Research Reactor Facility

SUBJECT: Response to Request for Additional Information dated April 20, 1994

Response to NRC Request for Additional Information dated April 20, 1994

MURR
Pool and Weir
SCALE: 1/2" = 1'-0"

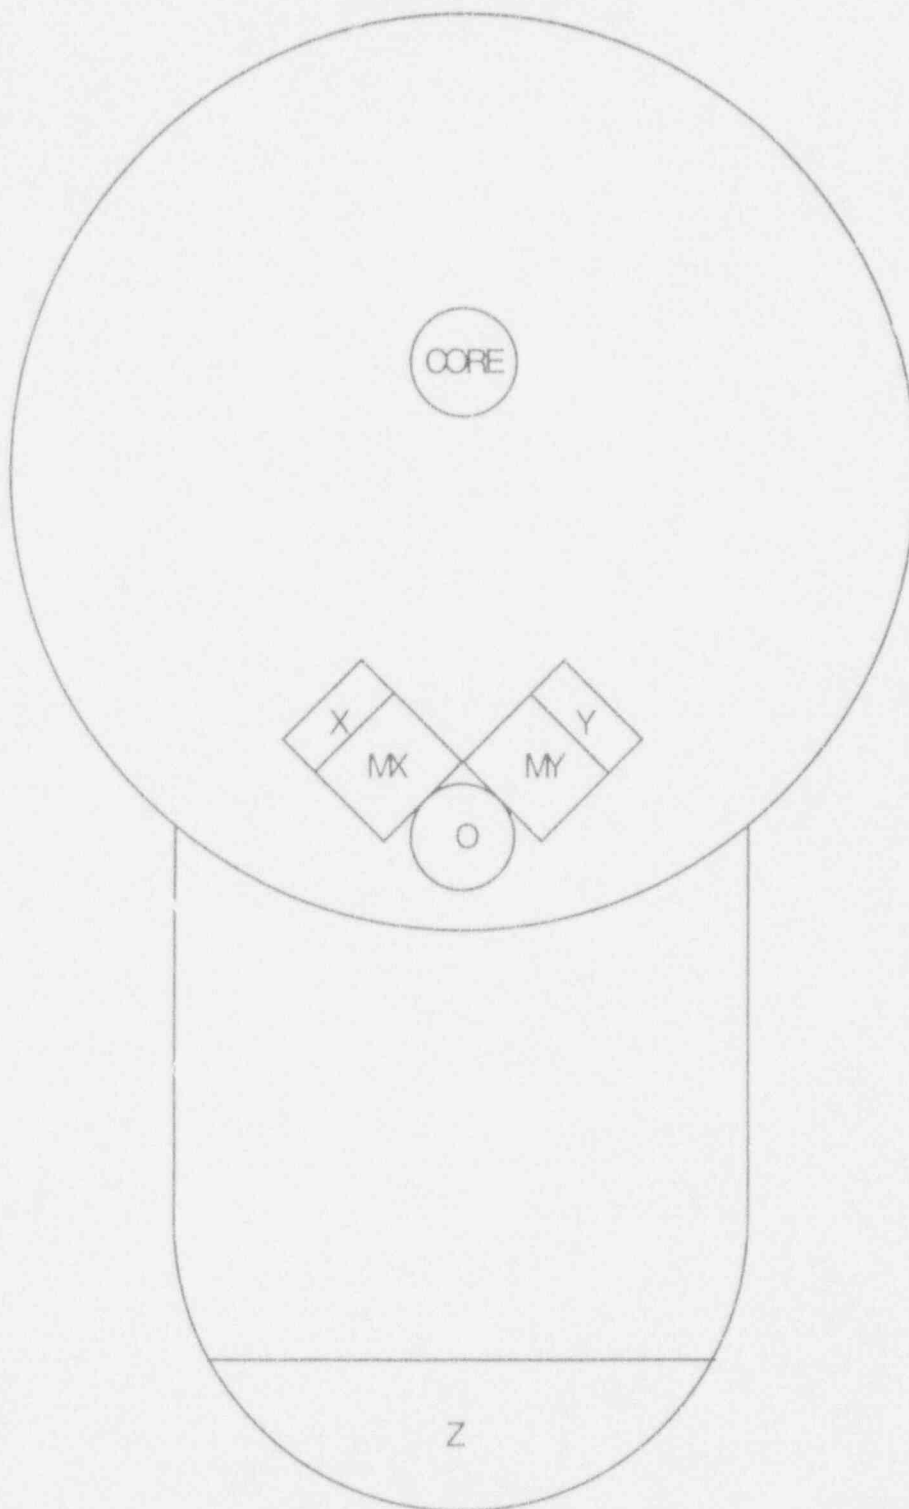
4. *Your amendment request states that the criticality aspects of fuel storage at MURR are not changed by the request. Please provide a discussion of storage racks, k-effective, and stored fuel cooling for the maximum amount of fuel that will be in storage during the period of the proposed increased possession extension.*

The MURR currently has 60 fuel elements at various levels of burnup. By May 31, 1995, the projected number of elements at MURR would reach 90 elements.

The attached diagram shows the fuel storage baskets in the MURR pool. Using the KENO code, we calculated $k_{eff} = 0.75$ for the baskets X, Y, MX, MY, O, fully loaded with new 775 gram U-235 elements. This is conservative, since elements stored in these baskets always have some burnup and are less than 775 g U-235. Similar calculations have shown that k_{eff} for the fully loaded Z baskets is less than 0.8. These in-pool storage locations are capable of storing 92 fuel elements.
